<b>DOCKETED</b>	
<b>Docket Number:</b>	19-BSTD-03
<b>Project Title:</b>	2022 Energy Code Pre-Rulemaking
<b>TN #:</b>	237142
<b>Document Title:</b>	Carrier Corporation Preliminary Comments
<b>Description:</b>	N/A
<b>Filer:</b>	System
<b>Organization:</b>	Carrier Corporation/Richard Lord
<b>Submitter Role:</b>	Public
<b>Submission Date:</b>	3/11/2021 4:18:33 PM
<b>Docketed Date:</b>	3/11/2021

## **Carrier Corporation Preliminary Comments**

**Values used by Fan Working Group to Determine Basic Limit  
65% fan efficiency assumed**

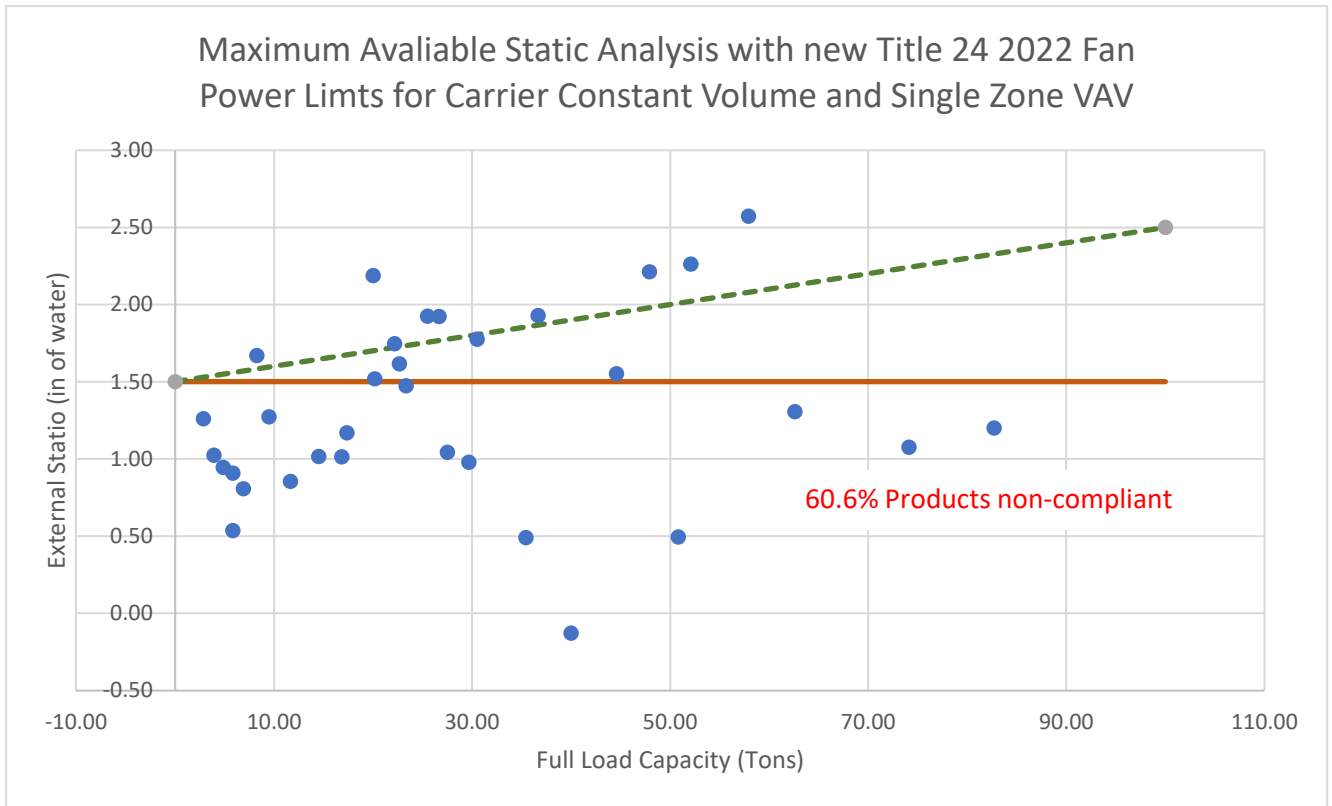
What they consider as duct losses does not align with the rating procedures used in AHRI 340/360 where the inlet/mixed air section, outlet transition are included in the unit fan power ratings. So, the true external static pressure is 3 in-H<sub>2</sub>O for VAV and 1.5 in-H<sub>2</sub>O for CV Systems. It is not clear why a VAV system would have double the applied external static as the old system power terminals are not longer used. Also, the external statics are no constant from 3 tons thru 150 tons and this allowance should vary by size.

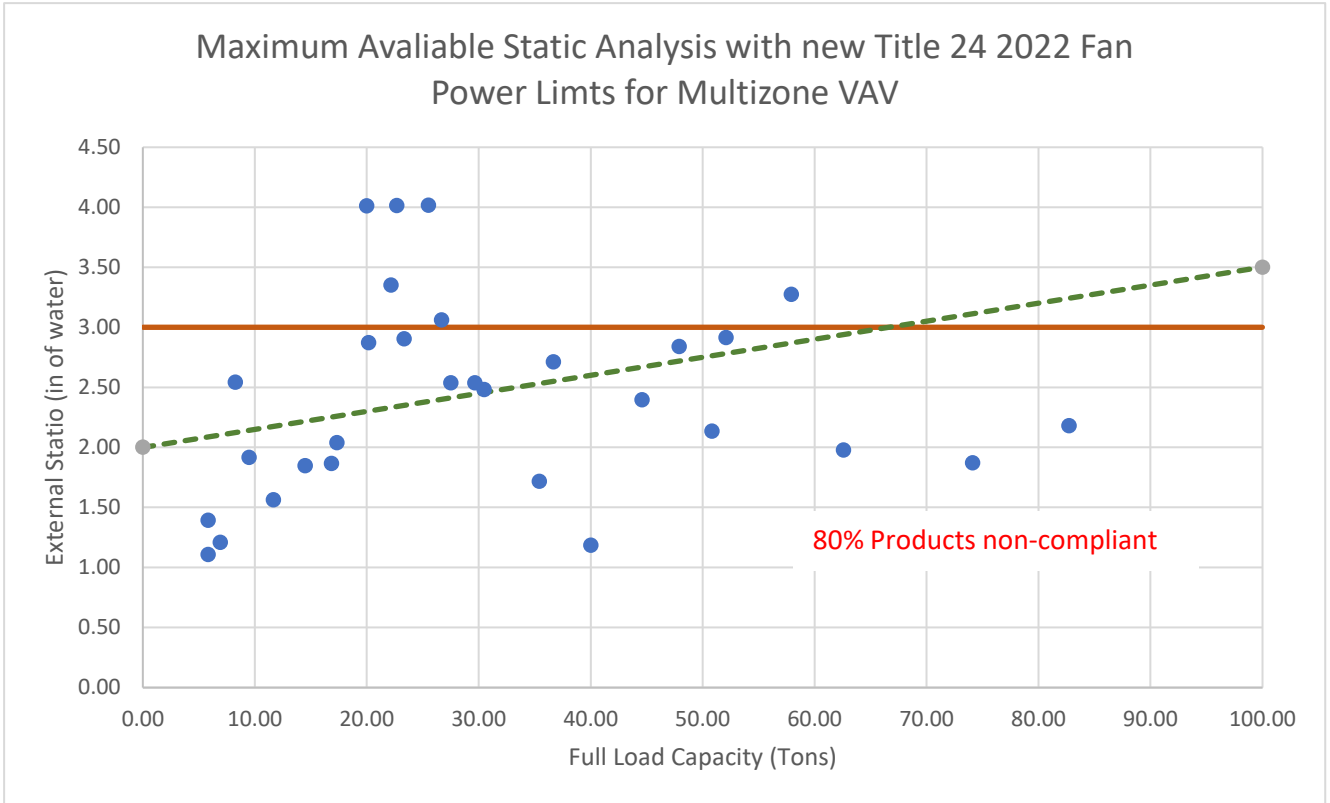
Below is the plot for the constant volume units. Each of the blue dots is the maximum external static that a unit with gas heat, an economizer, and MERV 13 filter could be applied with and meet the requirements of the table 140.1 A and 140.1 B

As you can see 60.6% of the units would not even be able to provide the assumed 1.5 in-H<sub>2</sub>O static which is shown by the orange line. The assumption on the 1.5 in-H<sub>2</sub>O static is probably OK for the smaller units but as the capacity increases so does the ductwork length and we believe a curve more like the green dashed line would be more appropriate.

We did the same analysis for the VAV multizone requirements which are different for the allowable watts/cfm and for the assumed external static of 3.0 inches. This is shown in the following curve.

80% of the products would not be able to provide the assumed static of 3 in-H<sub>2</sub>O. We do also feel the 3-inch static for all sizes is not a good assumption and we feel a number range from 2 in to 3 inch would be more appropriate. VAV has expanded and we build VAV multizone units from 6 tons to 150 tons.
